**STAFF REVIEW AND RECOMMENDATIONS  
PUBLIC HEARING  
AUGUST 4, 2021**

PRELIMINARY PLAT: **TALLERICO 2021**  
LEGAL DESCRIPTION: **SEC 17, T17N, R01W S.M., AK**  
PETITIONER: **NORTHERN QUALITY HOMES, LLC/HANSON LAND SOLUTIONS**  
SURVEYOR: **HANSON LAND SOLUTIONS**  
ACRES: **3.01 +/-** PARCELS: **3**  
REVIEWED BY: **FRED WAGNER** CASE: **2021-100**

**STAFF REVIEW AND RECOMMENDATIONS**

**PRELIMINARY PLAT: BRU-NETTE PARK**

A PLAT OF  
**TALLERICO 2021**  
A REPLAT OF  
**LOT 2, BLOCK 5 TALLERICO (93-142)**  
PALMER RECORDING DISTRICT  
STATE OF ALASKA  
LOCATED WITHIN  
SE 1/4 SEC. 17, T.17N. R.1W. SM, AK  
CONTAINING 3.01 ACRES MORE OR LESS

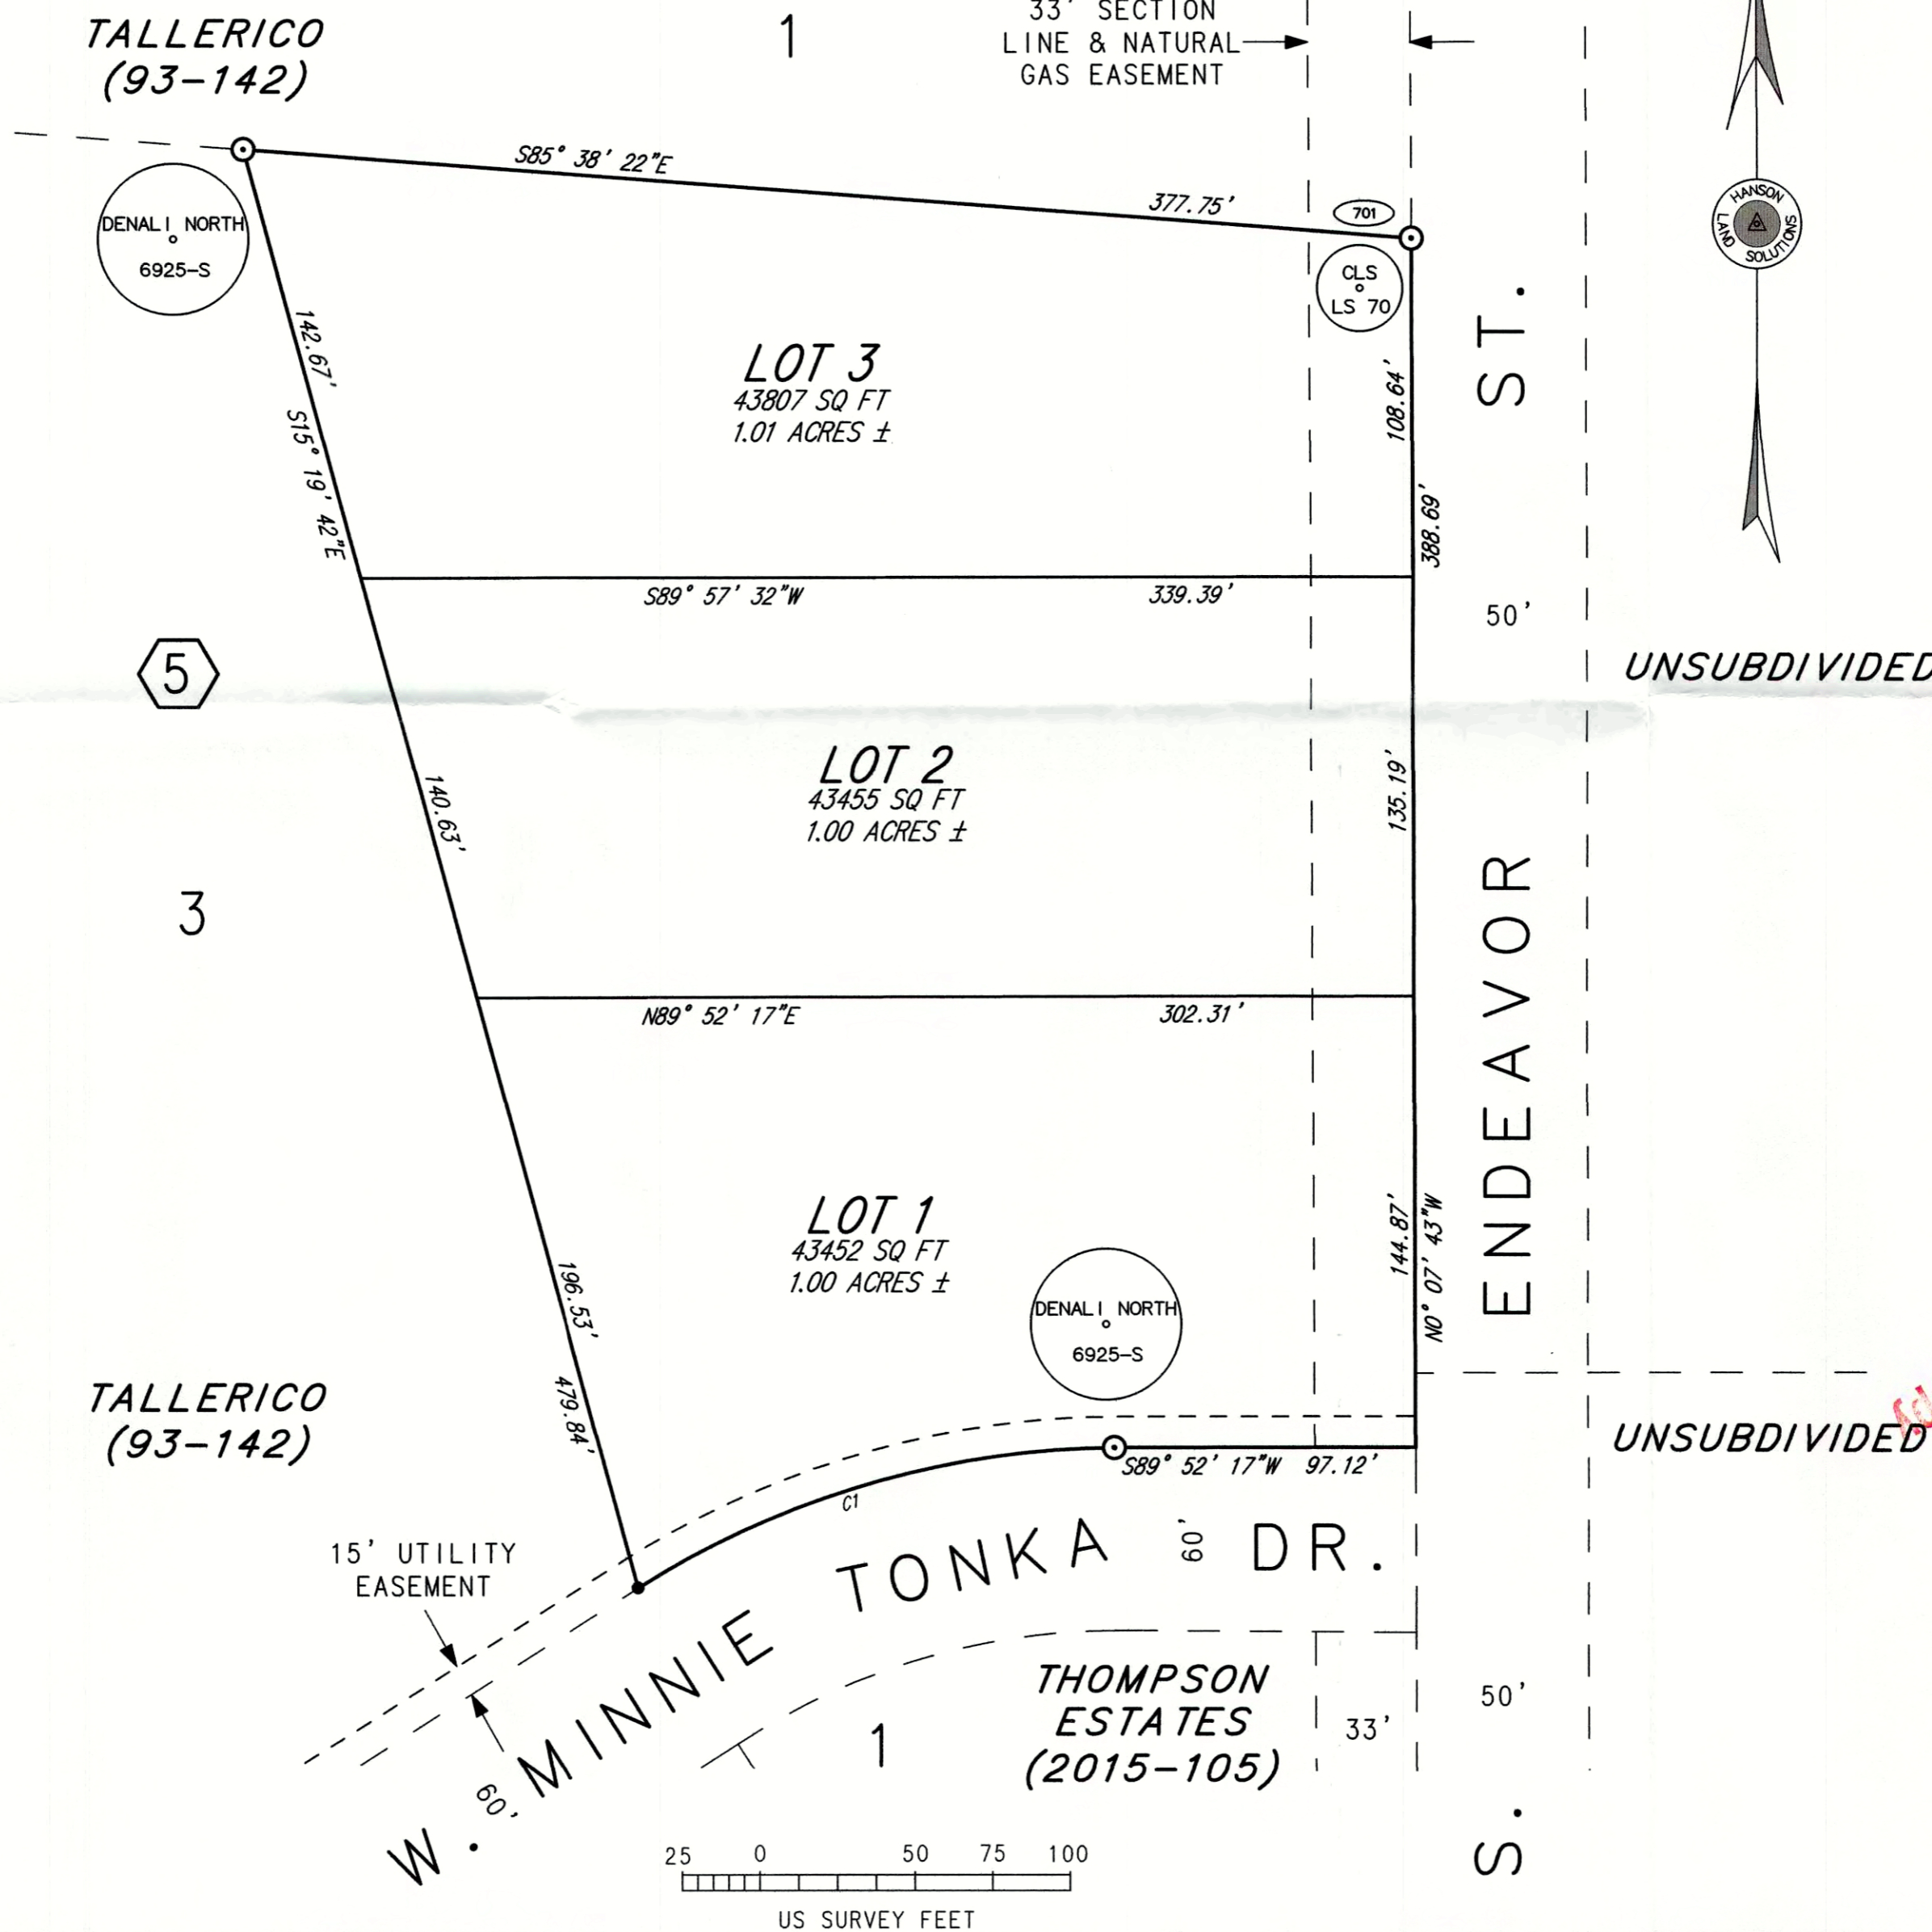
**Utilities:** (Exhibit E) ENSTAR has no comments or recommendations. MTA has no comments. GCI has no comments or objections to the plat. MEA requests a newly recorded easement be shown on final plat (see *Recommendation #4*).

[EXTERNAL EMAIL - CAUTION: Do not open unexpected attachments or links.]  
MEA comments to include the attached easement in the plat notes.
